**RESPONSES TO THE U.S. ENVIRONMENTAL PROTECTION AGENCY AND OHIO  
ENVIRONMENTAL PROTECTION AGENCY COMMENTS ON THE RESPONSE TO THE U.S.  
ENVIRONMENTAL PROTECTION AGENCY AND OHIO ENVIRONMENTAL PROTECTION  
AGENCY COMMENTS TO THE AREA 2, PHASE I SITE PREPARATION PACKAGE**

**RESPONSE TO USEPA AND OEPA COMMENTS ON  
THE RESPONSE TO USEPA AND OEPA COMMENTS  
TO THE AREA 2, PHASE I  
SITE PREPARATION PACKAGE**

**FERNALD ENVIRONMENTAL MANAGEMENT PROJECT  
FERNALD, OHIO**

PROJECT NAME  
**WASTE UNITS REMEDIATION  
SOUTHERN WASTE UNITS - SITE PREPARATION PACKAGE**

PREPARED UNDER PARSONS PROJECT ORDER NUMBER SCEP/P0165	DOE PROJECT NO. WBS 1.1.1.2.3.6 00-90701	DRAWING INDEX CODE NO. 92X-5900-N-00291	SHEET NO. N0003	REV. NO. 1
---	--	--	--------------------	---------------

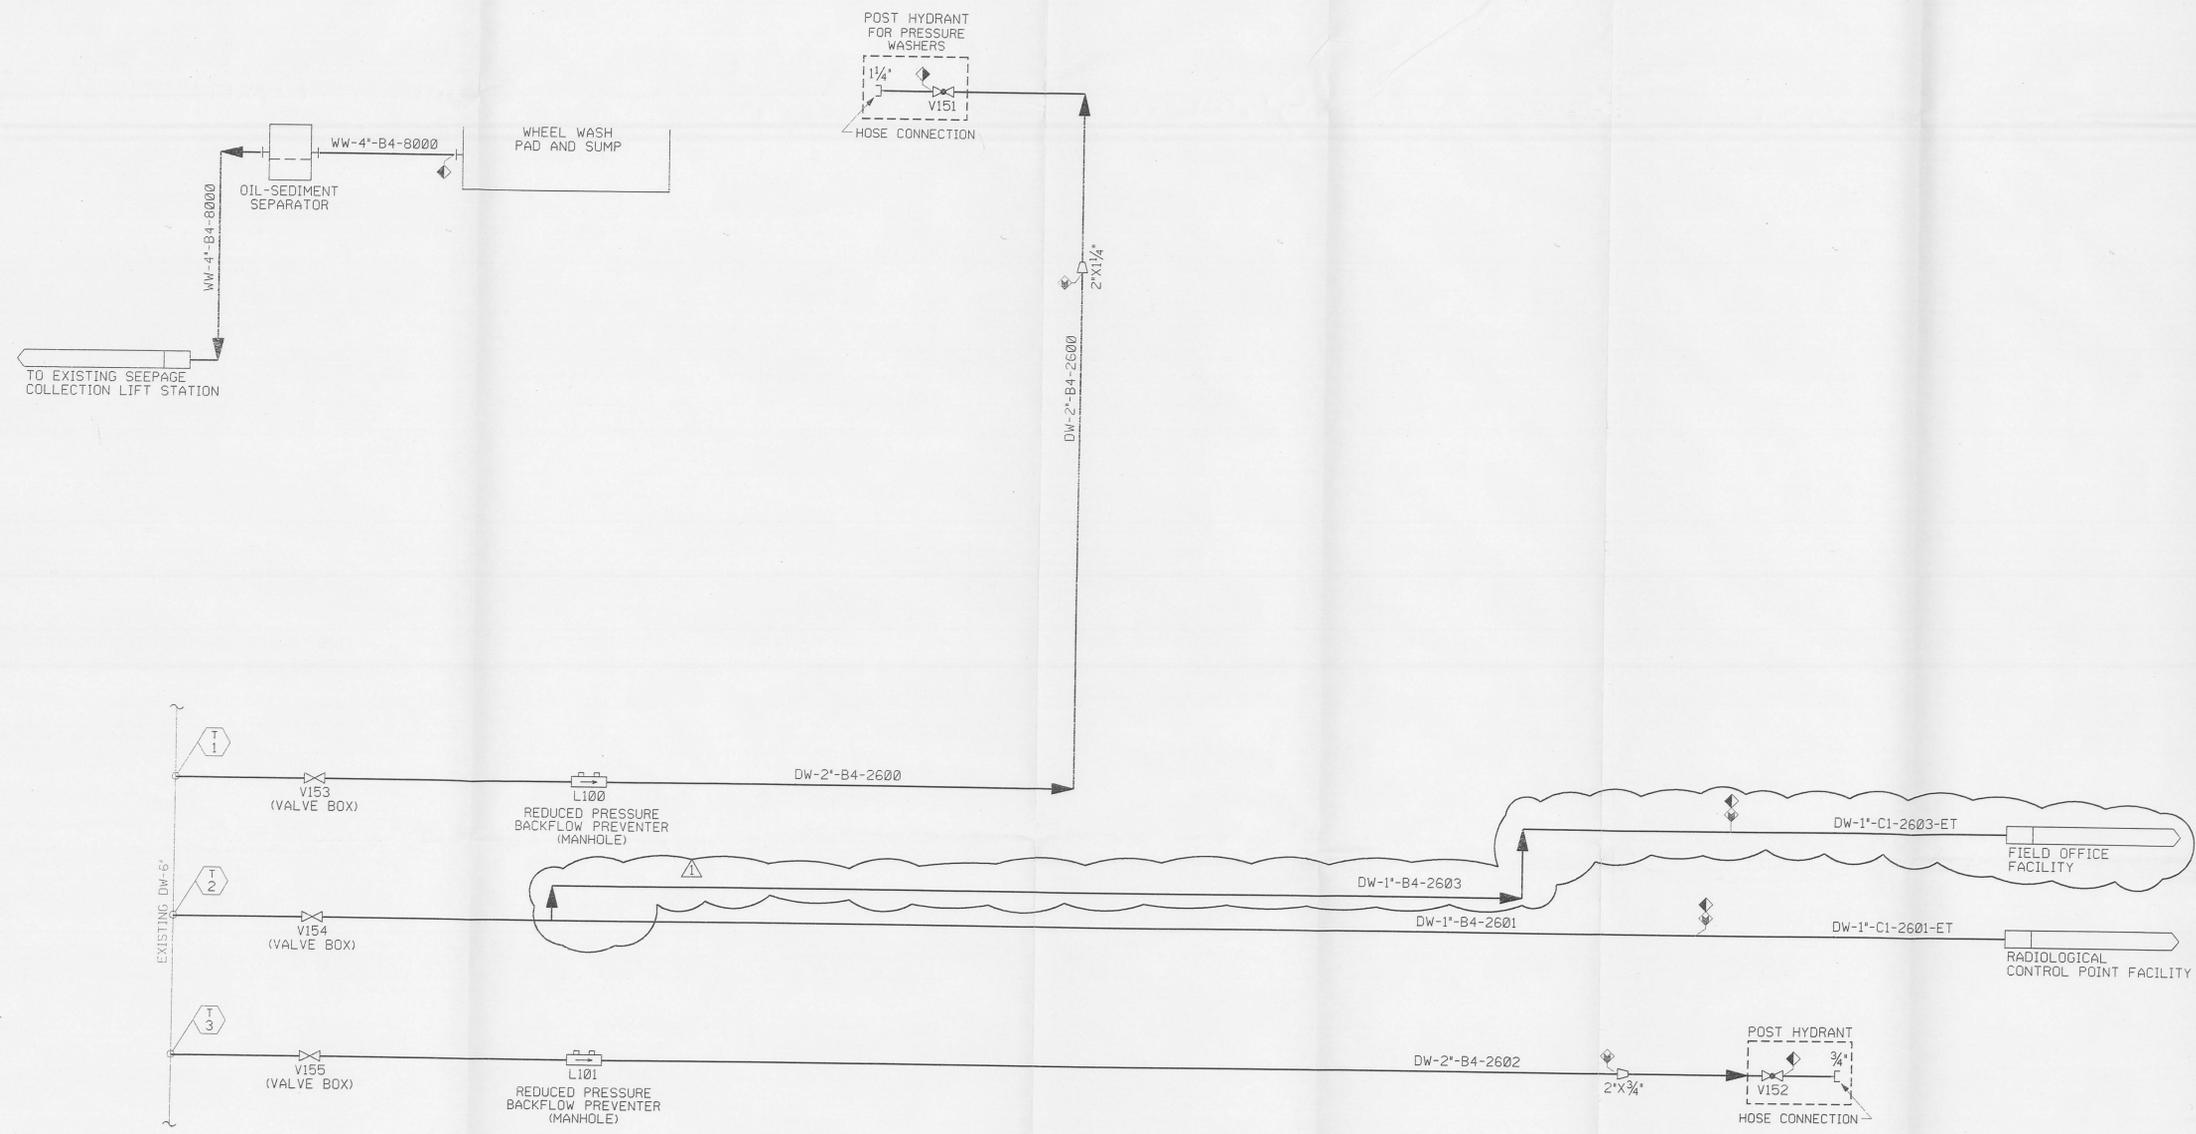
Comment: It should be noted that not all the design drawings are included in the design package. Piping and instrument, and electrical drawings were not included.

Response: Only the General (X series), Civil (G series), and one Mechanical (N series) drawings have been revised with the revised documents that were submitted to EPA. The electrical drawings have not been revised. Therefore, the electrical drawings are not resubmitted to the USEPA and OEPA (because they did not change from the set previously submitted). One mechanical

drawing (N0003) was inadvertently left out of the package, and is attached.
